"TIMBERWOLF ADDITION"

RE: S/D 99-72 -- One-Step Final Plat of TIMBERWOLF ADDITION

STAFF REPORT
(One Step Final Plat Approved 11/18/99)

CASE NUMBER: S/D 99-72 -- TIMBERWOLF ADDITION

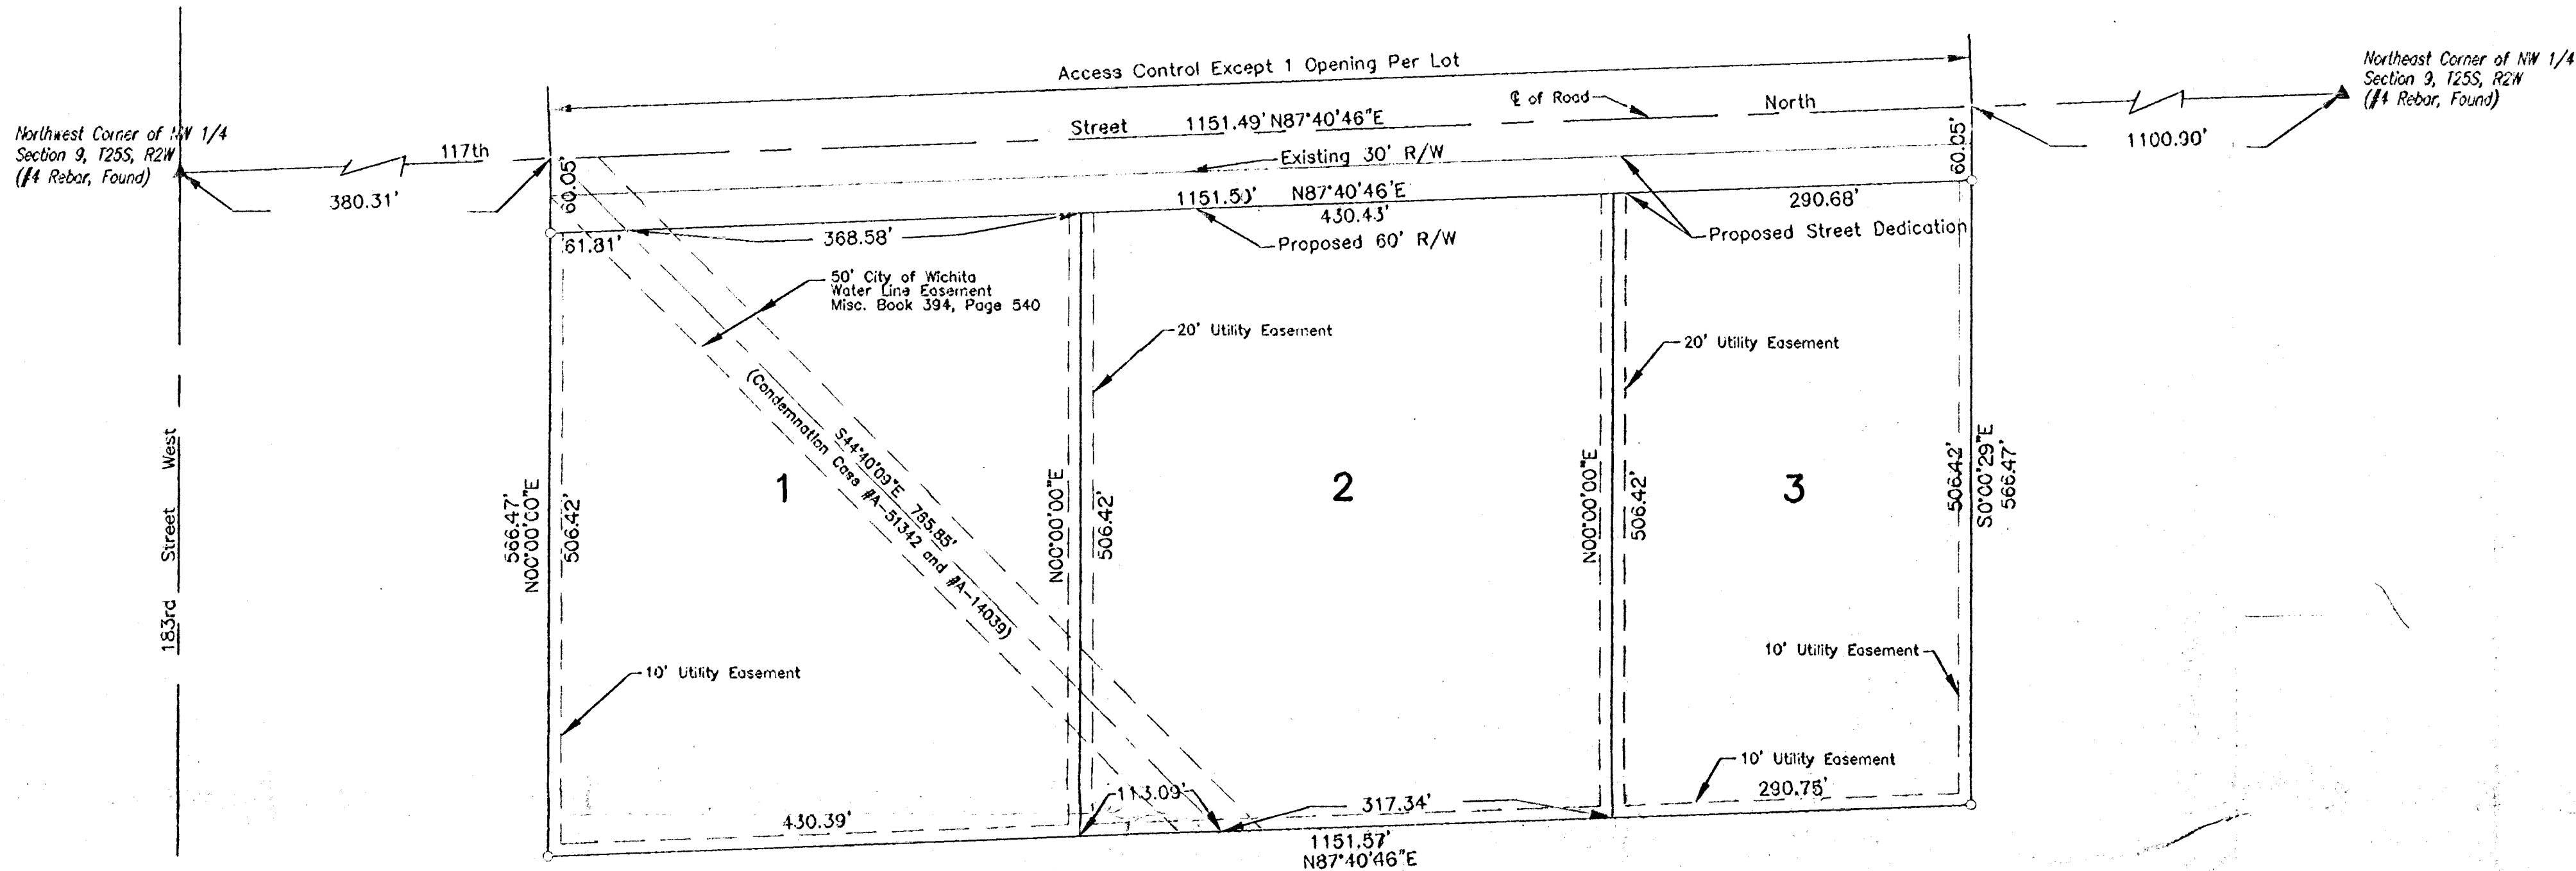
- B. Bearings and recording data need to be added for the water line easement. Bearings and distances need to be added for all lot lines.
- C. **County Engineering** needs to comment on the status of the applicant's drainage plan. **The drainage plan is approved. Utility easements need to be added between the lots and along the perimeter.**

- D. The Applicant proposes to dedicate access control except for one opening per lot along 117th St. North. The face of the plat shall be revised to reference "one opening per lot". The plat's text shall note that the access controls are being dedicated to the appropriate governing body.

- E. The MAPC Chair should be revised to reference "Francis S. Garofalo".

- F. The County Commissioners signature block only requires the signature of Bill Hancock.
- G. The plat's text shall include language that a drainage plan has been developed for the plat and that all drainage easements, rights-of-way, or reserves shall remain at established grades or as modified with the approval of the applicable City or County Engineer, and unobstructed to allow for the conveyance of stormwater.
